METRO KNITTING & DYEING MILLS LTD (9509)

ACCORD
on Fire and Building Safety in Bangladesh

Site Observations

Rebars left in place for future building

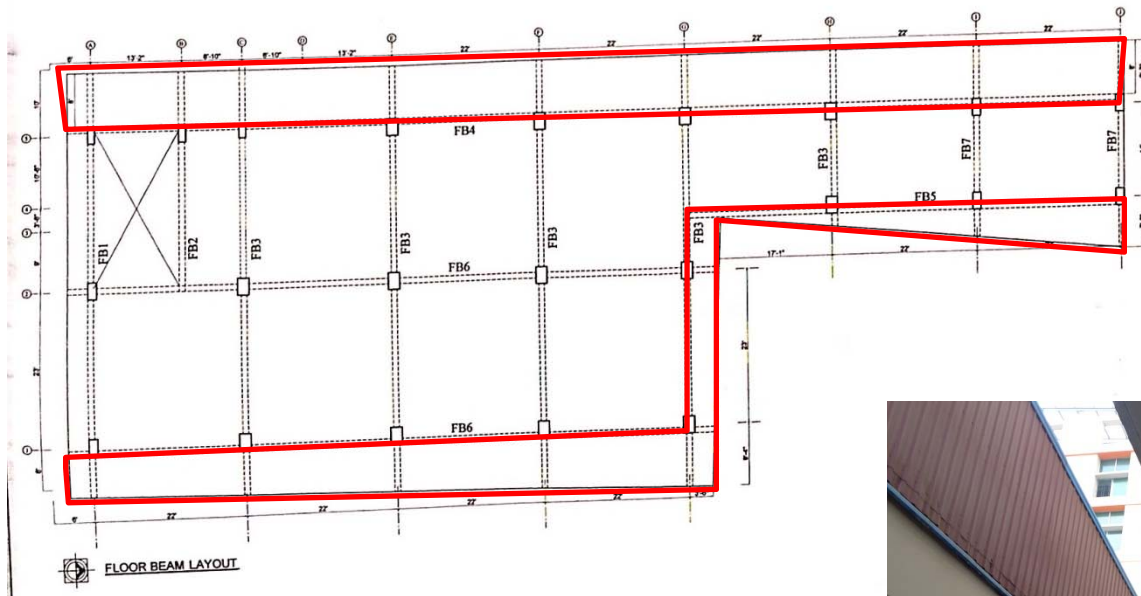
Rebars were left in place for the construction of a future adjacent building. The 2 building should be separated by a movement joint.

- Rebars to be cut and future building to be constructed with a movement joint.
